Subject: Supplemental Response to NRC "Request for Additional Information for Westinghouse Topical Report WCAP-15063-P, 'Westinghouse In-Reactor Creep Model'," dated September 10, 1998.

Supplemental Response to NRC
"Request for Additional Information for
Westinghouse Topical Report WCAP-15063-P,
'Westinghouse In-Reactor Creep Model',"
dated September 10, 1998

- Attachment 1. Re-write of WCAP-15063-P, as requested by Mr. R. Caruso of the NRC during the June 23, 1999 meeting. The re-write comprises the original topical report submittal as Section 1, "Westinghouse In-Reactor Creep Model" and the "Other PAD Model Changes", that were presented to the NRC during the September 15, 1998 meeting, as Section 2. The "Other PAD Model Changes" were documented in NSD-NRC-98-5810, November 13, 1998. As directed by Mr. R. Caruso, the topical report number remains the same (e.g., WCAP-15063-P); however, the title has been revised to more accurately account for all changes.

Figure 18

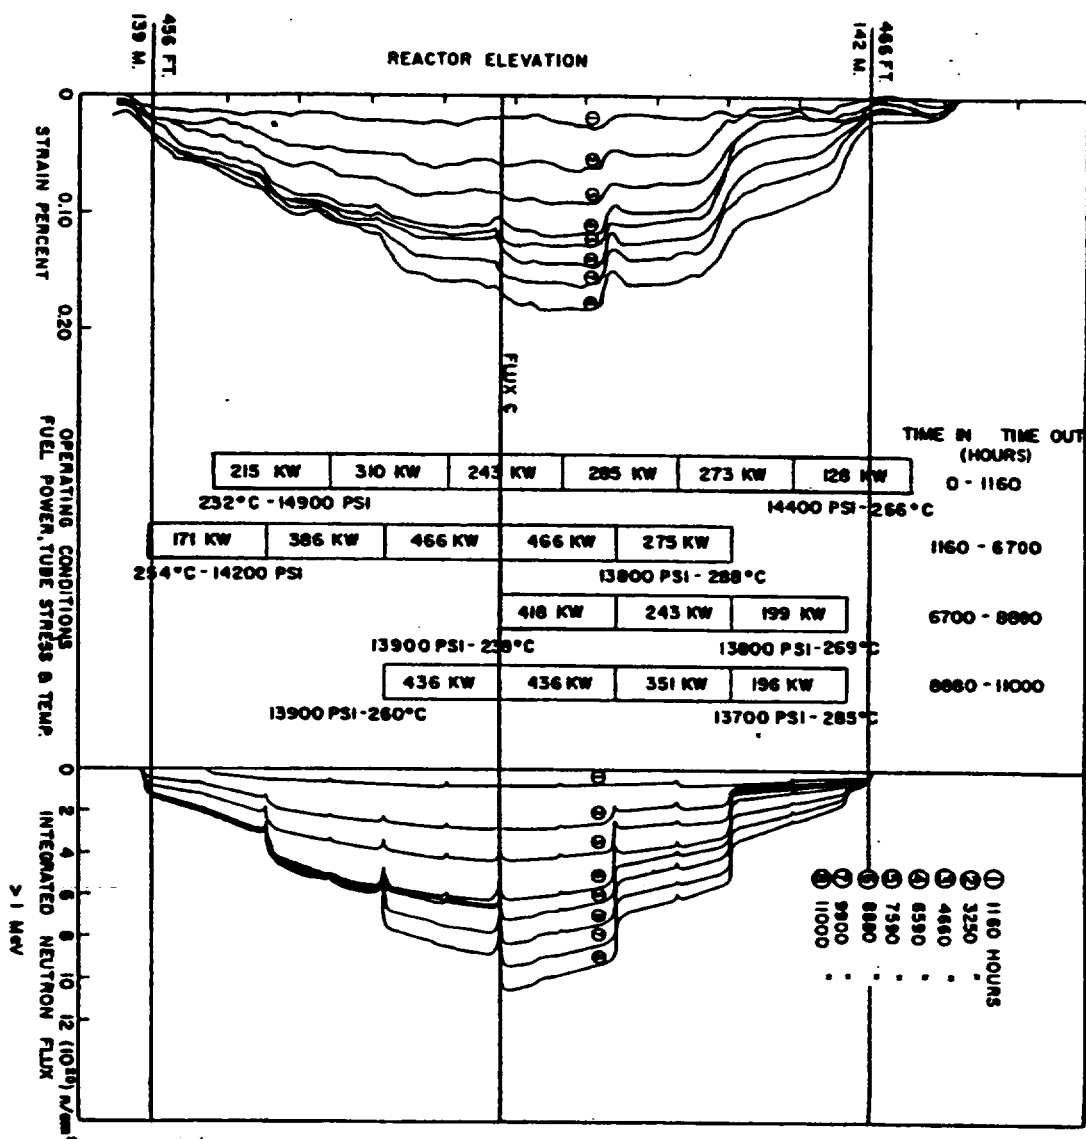
] ^{a, c}. The CW Zr-2 pressure tube may be added to WCAP-15063-P by modifying one sentence on Page 11 in the first paragraph of Section 3.2.1.2, adding text just after the modified sentence, modifying Table 3, adding one Figure A, and adding one reference. The sentence to be modified is:

Figure 18

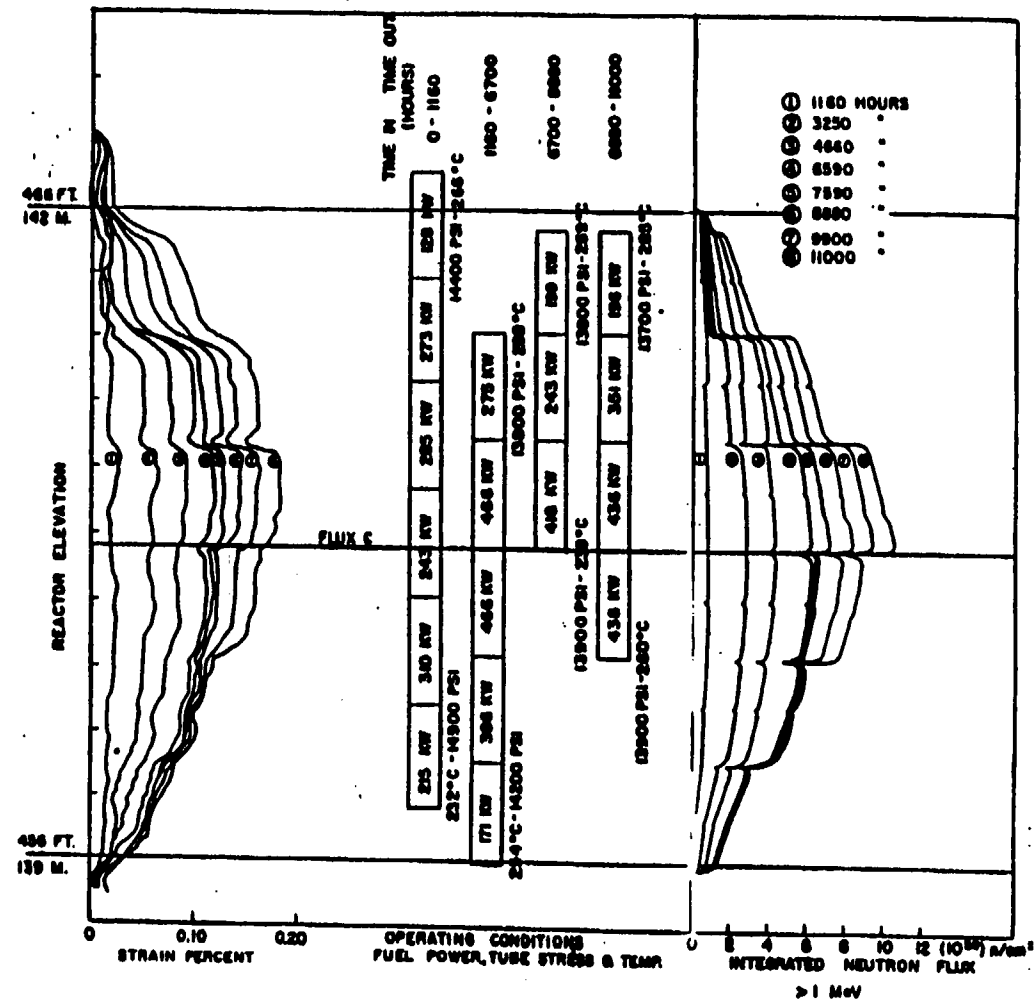
] ^{a,c}. The CW Zr-2 pressure tube may be added to WCAP-15063-P, Revision 1, Section 1, by modifying one sentence on Page 11 in the first paragraph of Section 3.2.1.2, adding text just after the modified sentence, modifying Table 3, adding Figure 18, and adding Reference 25. The sentence to be modified is:
